DALHOUSIE COMMUNITY ASSOCIATION

**Re: 593 Laurier West - D02-02-24-0079 & D01-01-24-0026
Zoning Amendment and OPA**

Further to our letter of 1 February, we wish to ensure that you are aware of certain possibly misleading assertions in the proposal documents with respect to the Escarpment.

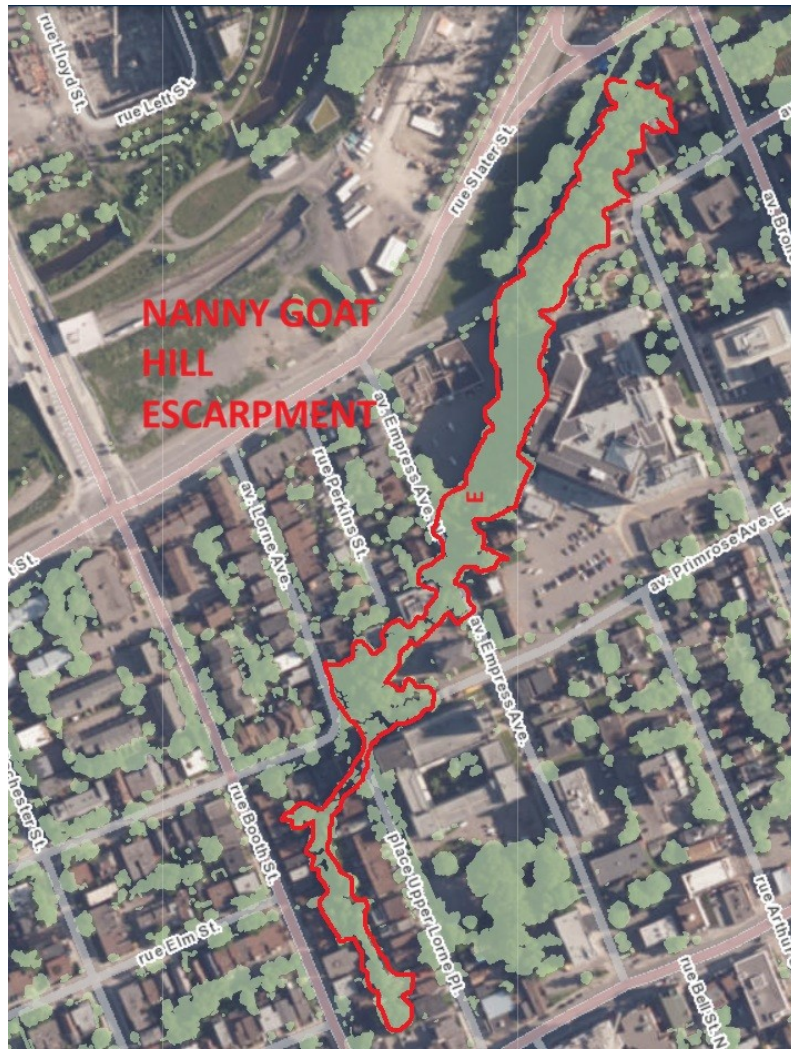
The proposed development site includes a significant chunk of the Escarpment. The Escarpment is shown on OP Schedule C11A (see below) and on that map

extends southwest to Empress St. encompassing an area of 0.6Ha. (Far greater than the 0.2Ha claimed in para. 4.14 below.)

In fact, the Escarpment continues southwards to about Booth and Spruce Street and constitutes a further 0.2Ha. See highlighted “Nanny Goat Hill Escarpment” map below.

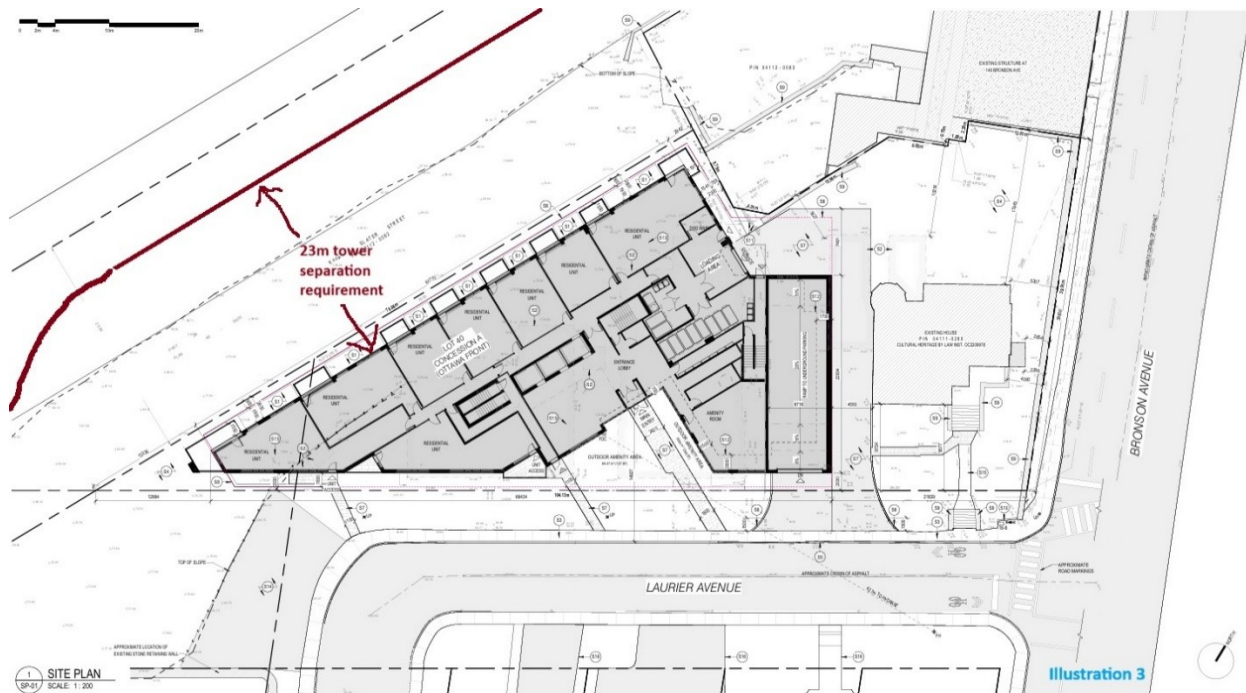
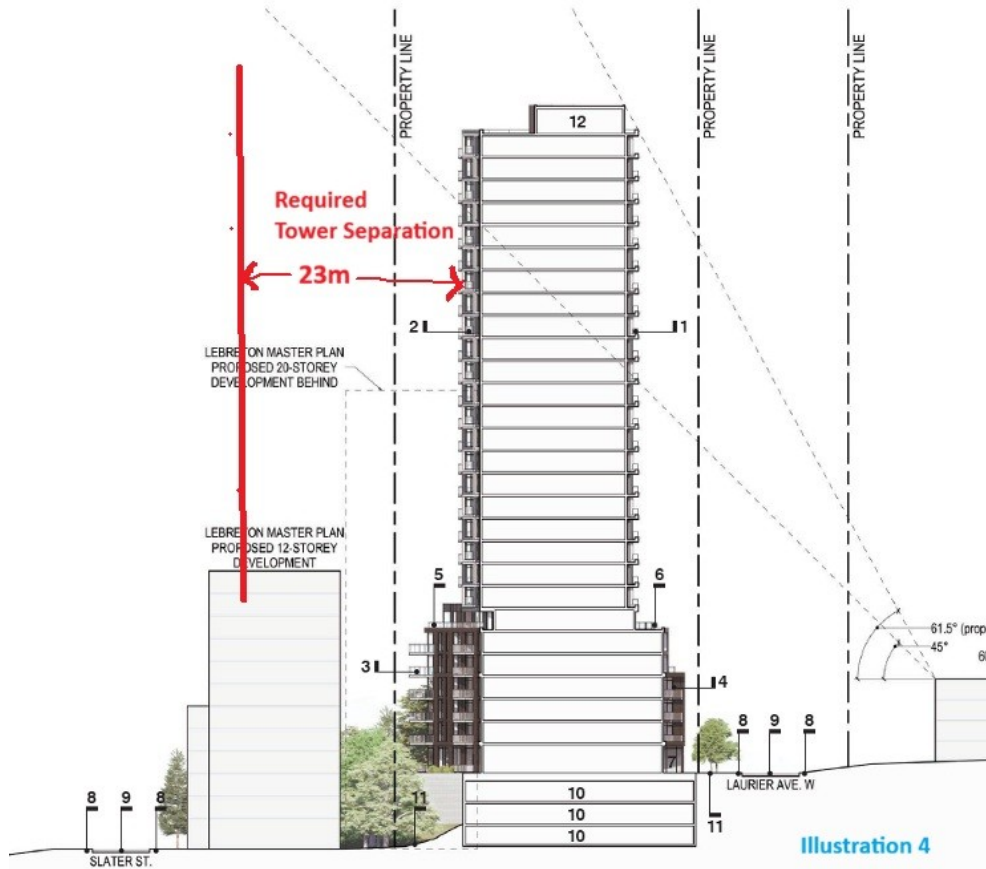
#5: UDRP has concerns about the building encroaching on the escarpment. The proponent asserts that the building is “atop” the escarpment. In fact, the development extends halfway down the escarpment.

#7: UDRP concerns about the building’s proximity to the northwest lot line. With the proposed building half of the width of the escarpment, there is not much buffer left vis-à-vis future towers below the escarpment. In fact, the proximity of the proposed building to the northwest lot line precludes tower development on the majority of the width of the land below the escarpment due to 23m tower separation criteria. See illustrations below.
